Request	-	Major Site Plan Review for a Community Health Center
Location	-	815 Navarre Avenue
Applicant/Owner	-	Health Partners of Western Ohio 315 North West Street Lima, OH 45801
Engineer/Architect	-	Technicon Design Group – Gillian Stechschulte 202 West Main Street Suite 301 Ottawa, OH 45875

Staff recommends approval of SPR25-0025, a Major Site Plan Review for a community health center at 815 Navarre Avenue, because its pedestrian-focused design promotes walkability in the area, the vehicular easement is only on Navarre Avenue, and the parcel is zoned appropriately for this use. In addition, it promotes several goals in the Forward Toledo Comprehensive Land Use Plan and is consistent with the Future Land Use Plan.

MAJOR SITE PLAN REVIEW
TOLEDO PLAN COMMISSION
REF: SPR25-0032
DATE: August 14, 2025
TIME: 2:00 P.M.

SITE PLAN

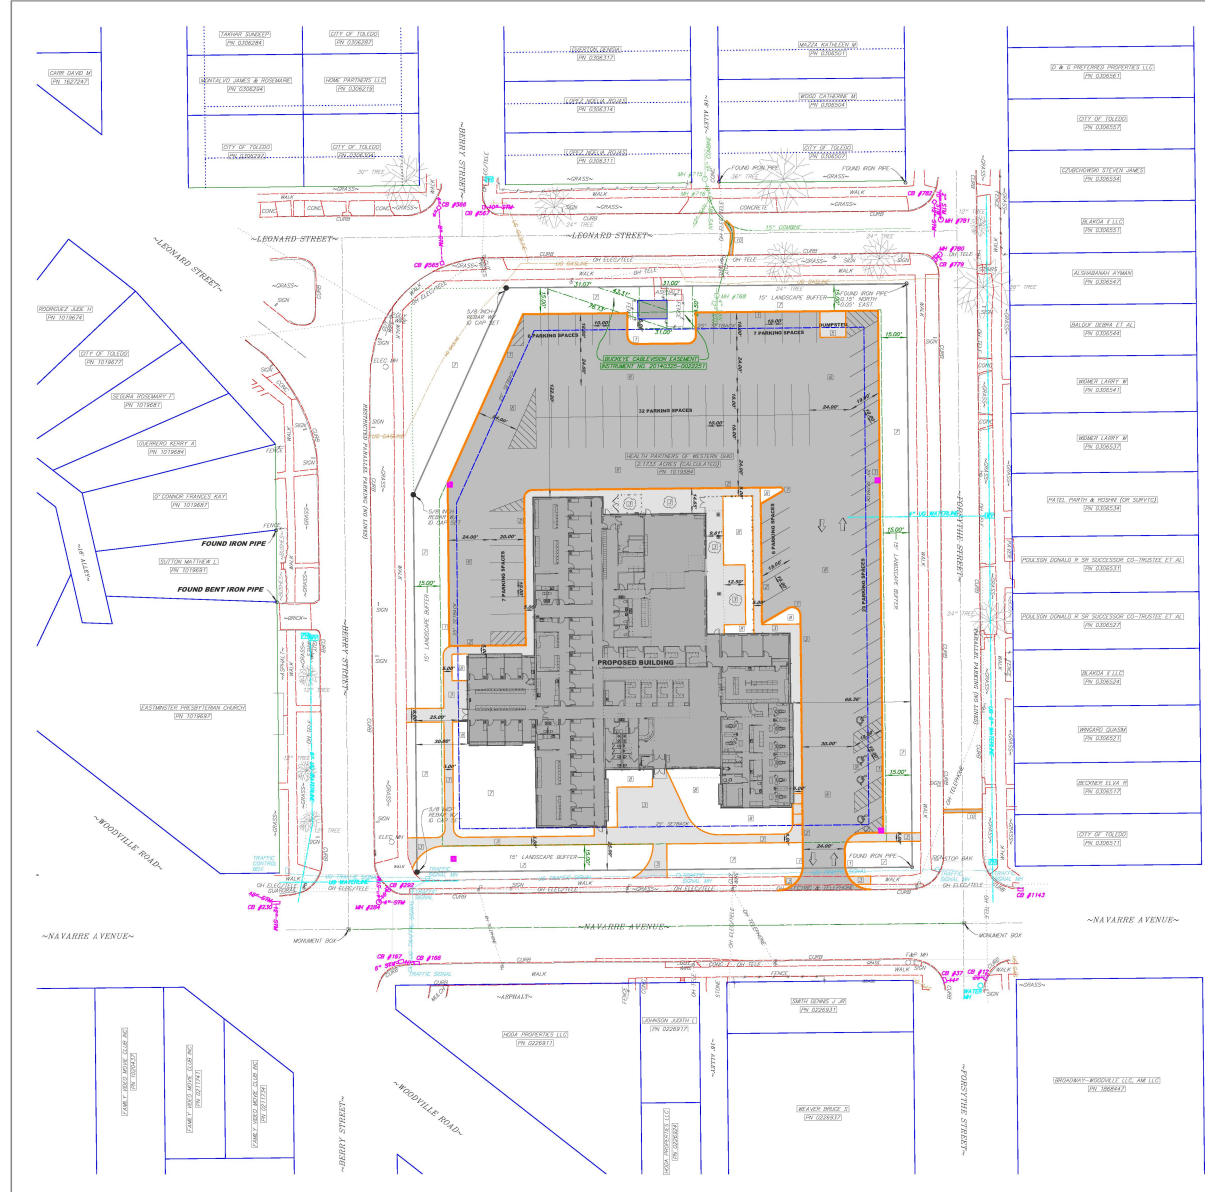
- The proposed building will be 24,400 square feet, requiring 122 parking spaces. The site plan only shows ninety (90) parking spaces. Due to the zoning and location, staff recommends approval on the proposed parking spaces.

- Bicycle parking is required for this site per TMC§1107.0304. Given the ninety parking spaces shown on the site plan, a total of nine (9) bicycle parking spaces are required.

- Per TMC§1107.1701 – Accessible Parking for Physically Disabled Persons, accessible parking spaces are required. Based on the number of parking spaces shown in the site plan, four (4) ADA parking spaces are required: three (3) car-accessible and one (1) van-accessible. The site plan shows four (4) accessible parking spaces that fit these criteria and satisfies the requirements.

- The site plan shows maneuvering aisles that are twenty-four feet (24') wide. Per TMC§1107.1911, maneuvering aisles must be twenty-five feet (25') in length. The Division of Traffic Management has included this requirement as a condition of approval.

22. One (1) bicycle parking slot shall be provided per ten (10) parking spaces pursuant to Off-Street Parking Schedule A in TMC§1107.0304. A total of nine (9) bicycle parking spaces are required to be provided on site in accordance with TMC§1107.0900. **Not acceptable as depicted on the site plan. A revised site plan shall be submitted to the Plan Director depicting the location and quantity of bicycle parking spaces.**

LANDSCAPE PLAN

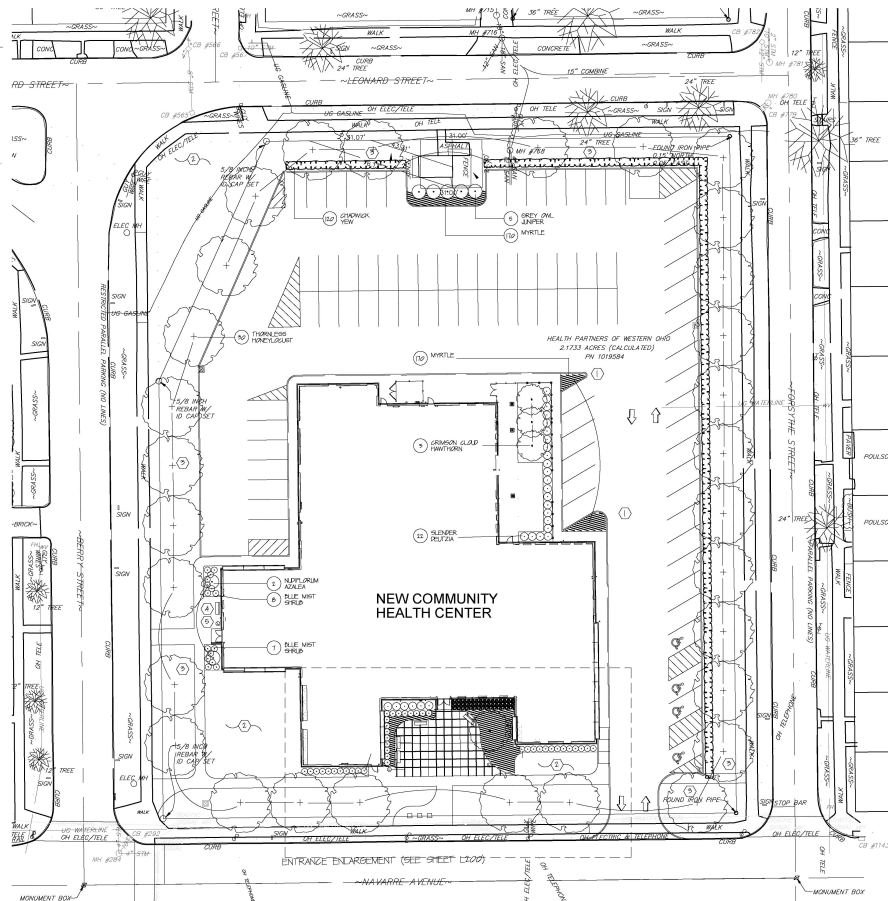
Navarre Avenue and Leonard Street have a frontage of 285', requiring ten (10) trees for each frontage. Forsythe Street and Berry Street have a frontage of 340', requiring twelve (12) trees for each frontage. The frontage greenbelt requires a total of forty-four (44) trees in total while the landscaping plan submitted only shows thirty (30) trees. A revised landscaping plan shall be submitted depicting the appropriate number of trees in the frontage greenbelt and listed as a condition of approval.

- b. As part of the frontage greenbelt, a solid evergreen hedge is required to screen the parking lot so that no headlights of any vehicles can be seen from the public street per TMC§1108.0202(B)(2). On the site plan, there is a solid hedge on the northern and eastern sides, but not the western side. The southern side is blocked by the primary structure. A revised landscaping plan shall be submitted depicting the solid evergreen hedge along the western side of the parking lot and listed as a condition of approval.

- c. The dumpster must be screened by a wall with a minimum height of six feet (6') per TMC§1108.0203. The dumpster screening shown in the site plan is five-feet, six-and-a-half inches (5'6.5") in height. A revised landscaping plan shall be submitted depicting the appropriate dumpster screening and listed as a condition of approval.

- f. The interior landscaping that is shown on the landscaping plan is: ninety-three (93) shrubs, four (4) canopy trees and a total of 1,242 perennials/groundcover. There is landscaping at all major entrances and landscaping visible on each side, but not along all portions of the building. There is a parking row without a terminal island. All portions of the parking lot are within one-hundred linear feet (100') of a landscaped area.

- g. The interior landscaping is missing fourteen (14) canopy trees, twenty-four (24) two-inch (2") caliper trees and landscaping along all portions of the buildings. The interior landscaping has an excess of thirty-nine (39) shrubs and 1,242 perennials/groundcover that is not counted. A revised landscaping plan shall be submitted depicting the location and appropriate quantity of interior landscaping and listed as a condition of approval.

- a. A fifteen-foot (15') frontage greenbelt along Navarre Avenue, Forsythe Street, Leonard Street and Berry Street per TMC§1108.0202. The greenbelt shall consist of ten (10) trees on Navarre Avenue and Leonard Street and twelve (12) trees on Forsythe Street and Berry Street. **Not acceptable as depicted. In total on the site plan, there are thirty (30) trees depicted in the frontage green belt instead of the required forty-four (44) trees. A revised landscaping plan shall be submitted for review and approval by the Plan Director.**

- b. Dumpster screening per TMC§1108.0203. **Not acceptable as depicted. The screening wall is five-feet six-and-a-half-inches (5'6.5") in height instead of the required six feet (6'). A revised site plan shall be submitted depicting the appropriate dumpster screening.**

- c. Perimeter parking lot landscaping along parking areas adjacent to a street per TMC§1108.0204(B.9). A continuous shrub row shall per provided on all frontages that are abutting the parking lot. **Not acceptable as depicted. The shrub row is only present on the northern and eastern frontages. A shrub row shall be added to the western frontage. A revised landscaping plan shall be submitted for review and approval by the Plan Director.**

- d. Interior parking lot landscaping TMC§1108.0204. Eighteen (18) canopy trees and fifty-four (54) shrubs shall be provided. **Not acceptable as depicted. Interior landscaping does not contain the required number of canopy trees. A revised landscaping plan shall be submitted for review and approval by the Plan Director.**

- e. Interior site landscaping per TMC§1108.0205. Twenty-four (24) two-inch (2") caliper trees, plantings along all portions of the building that are visible from public street right-of-way and landscaping at all major entrances. **Not acceptable as depicted. Interior landscaping is not present along all portions of the building that are visible to the public nor is there the required number of canopy trees. A revised landscaping plan shall be submitted for review and approval by the Plan Director.**
